MANPRINT ASSESSMENT OF THE
HIGH MOBILITY MULTIPURPOSE WHEELED VEHICLE
HEAVY VARIANT (HMMWV-HV)
(Contract MDA903-83-C-0033)

March 1988

HIGH MOBILITY MULTIPURPOSE WHEELED VEHICLE HEAVY VARIANT (HMMWV-HV)

Figure 3.2.1. Rear door latching mechanism.

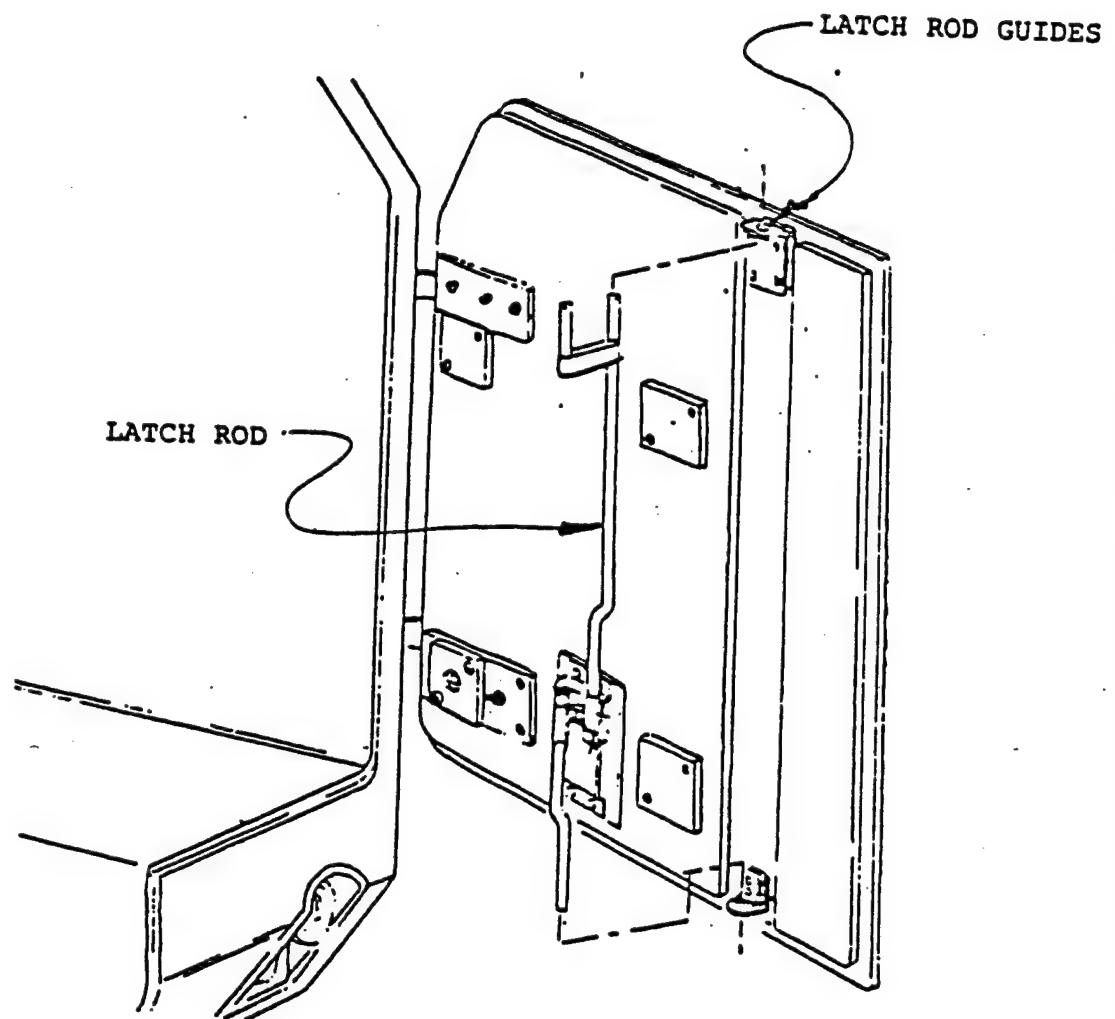
The rear doors for both the mini- and maxi-ambulances have inadvertently opened during normal operation. The hardware and latching mechanisms involved are shown in Figure 3.2.1.

Unsecured doors pose a safety hazard to personnel inside the enclosure. May require unscheduled stopping for the ambulance.

To achieve positive locking of the rear doors:

Figure 3.2.2.1. Rear entry steps.

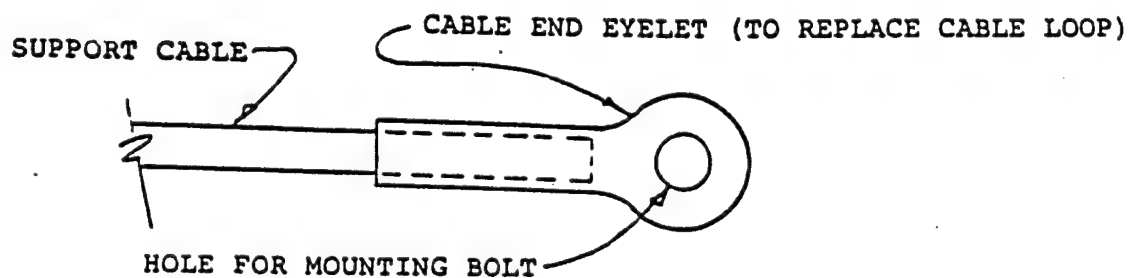
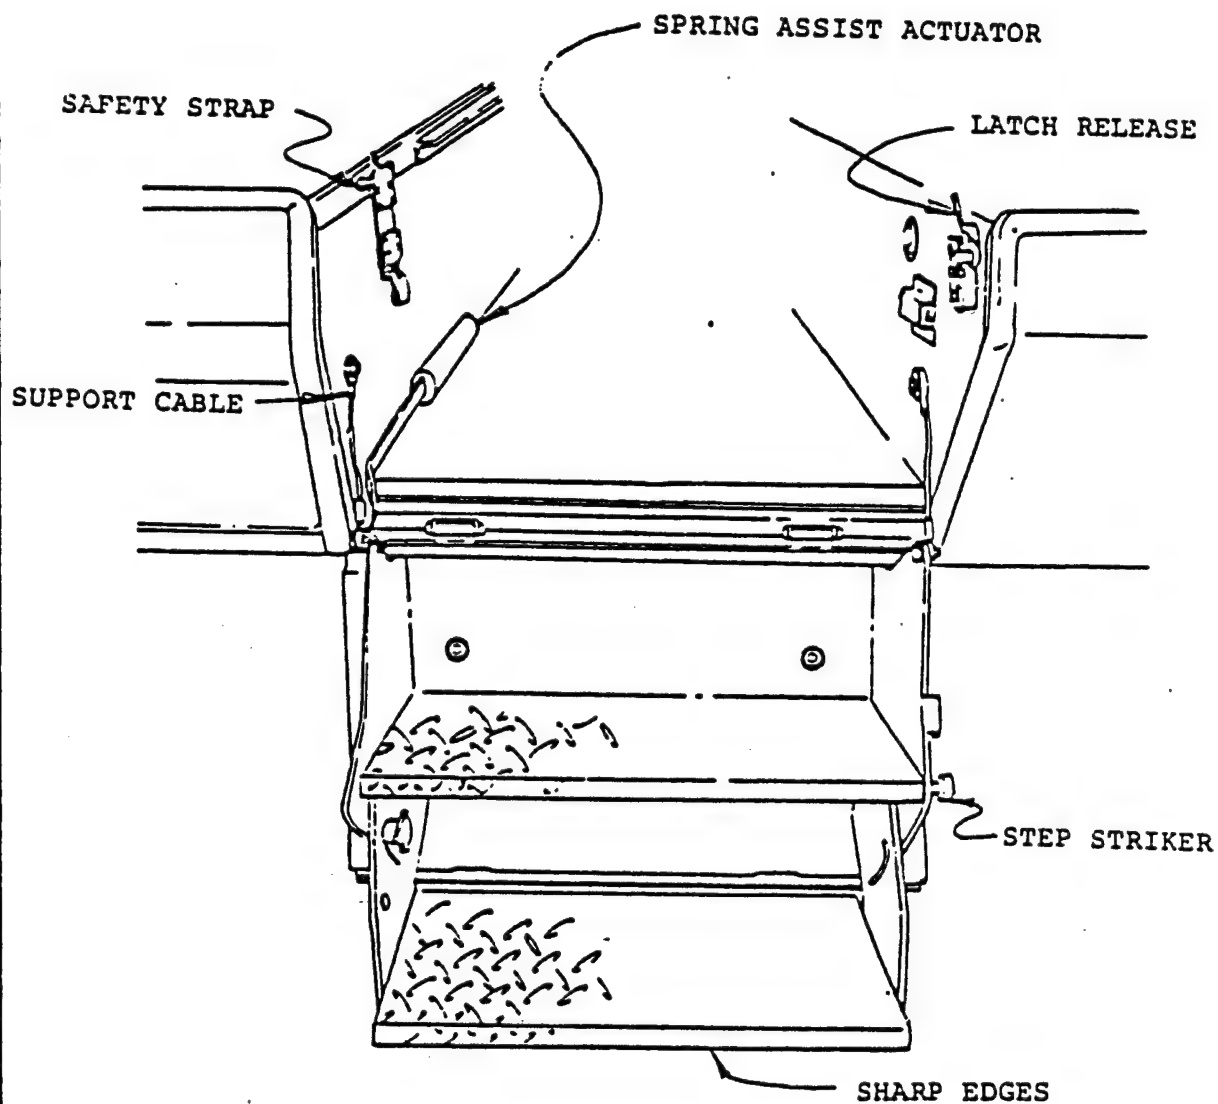
- a. The stair release latch is stiff, prone to sticking, and interferes with the litter support strap in the maxi-ambulance (see Figure 3.2.2.1).
- b. The safety strap for stowed position is hidden from operator's view while the operator is attaching or unattaching the strap hook.
- c. Sharp edges on steps have caused lacerations of the operators' hands.
- d. The stair support cables have come off of their attachment fasteners (see Figure 3.2.2.2).
- e. The mini-ambulance step seat (used while steps are in stowed position inside the van) restricts the headroom of a seated aidman.

a. Design the latch with an increased compound lever advantage. Change the direction of the release motion 90 degrees to existing. Move litter support strap to avoid interference.

b. Design a positive latch lock that eliminates the safety strap requirement. Integrate a dual latch system for both sides of the step that mounts to the steps with a single release handle. This would move the step striker from the steps to inside the van. (AM General installed a dual latch system at the end of the operational test; no functional data is available.)

c. All sharp edges should be eliminated.

d. Stair support cables could be redesigned to incorporate the cable and eyelet (see Figure 3.2.2.1).

e. Add a warning to the operators manual and locate a warning at the stair seat to avoid possible injuries.

DESCRIPTION
Figure 3.2.2.2. Support cable.

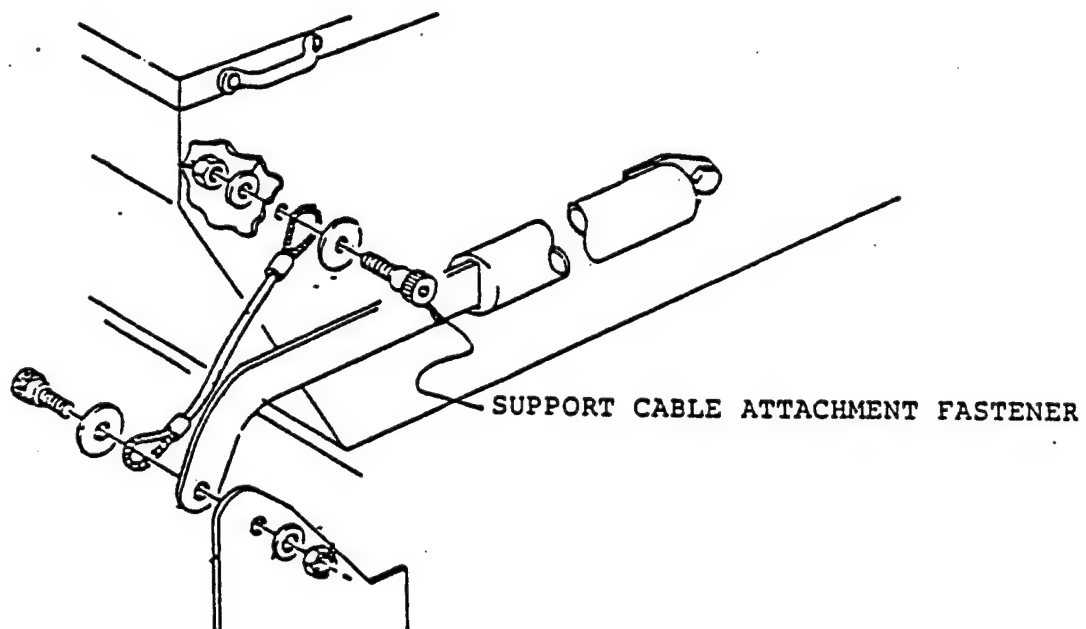
The step latch hardware, when fouled with dust, malfunctions. The motion to actuate the release lever is lateral to operator's frontal plane and is difficult to grasp in order to release. The stair support cable loops wear, increasing their diameter and allowing them to come off their mounting fasteners (see Figure 3.2.2.2).

Figure 3.2.3. Aidman and ambulatory patient securing.

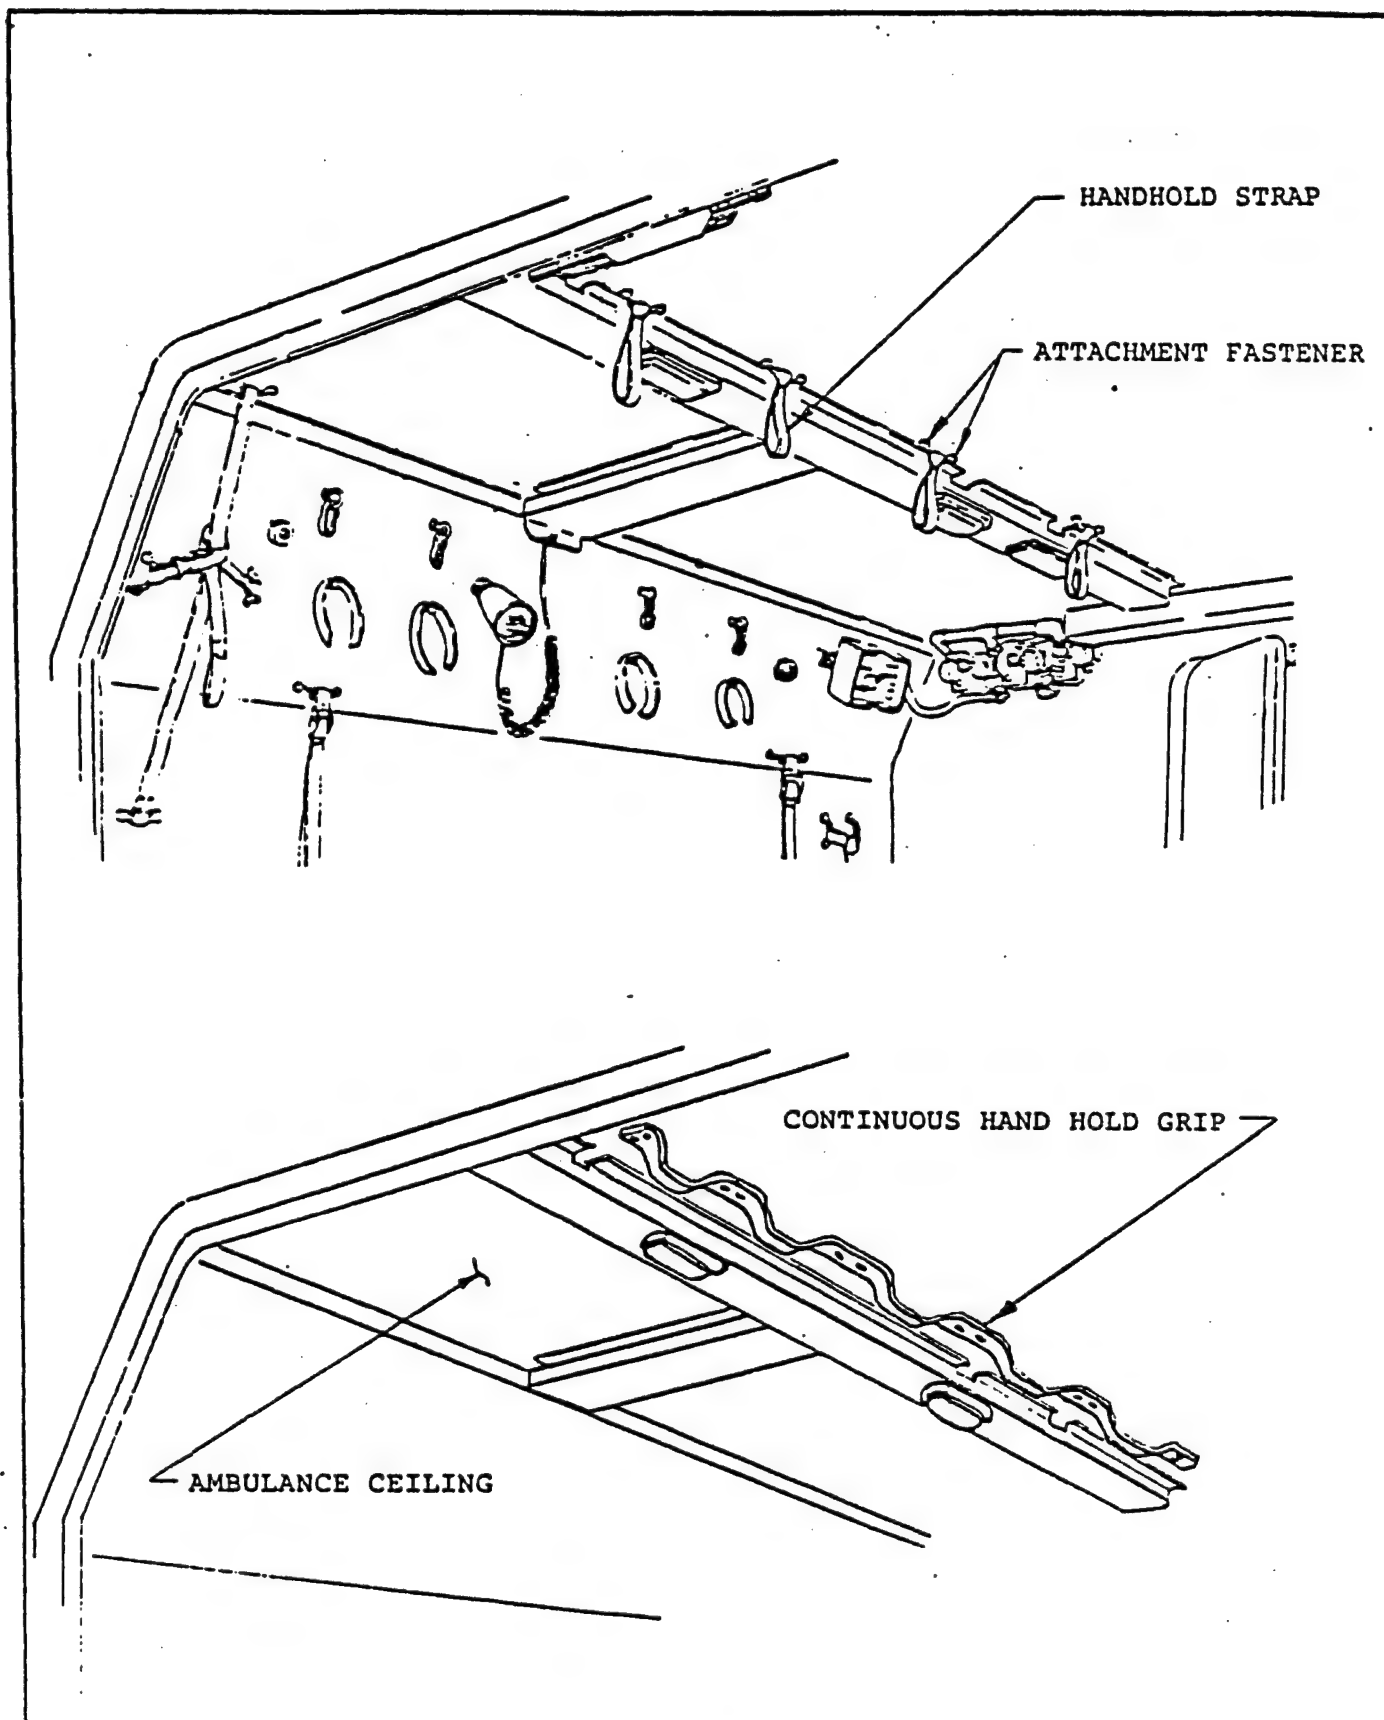
c. The mini-ambulance has handhold straps for use by seated ambulatory patients. The securing fasteners frequently failed, rendering the strap useless. It is also difficult to slide hands in and out of the hand strap loop (see Figure 3.2.3).

a. Incorporate a self-winding (retractable) seat belt restraint into the split between the seat and back of the ambulatory seat in the mini-ambulance. Incorporate this seat and restraint system into the maxi-ambulance (the maxi-ambulance upper litter rack could then tilt up to provide a storage area for ambulatory patient personal gear).

b. Add four handhold straps into the maxi-ambulance similar to the hand straps in the mini-ambulance. This will augment the existing four handholds provided by the looped upper litter support straps.

c. Incorporate a handhold system such as a continuous handhold strap as shown in the lower portion of Figure 3.2.3. This will give aidmen a handhold while attending to upper litter patients in the maxi-ambulance.
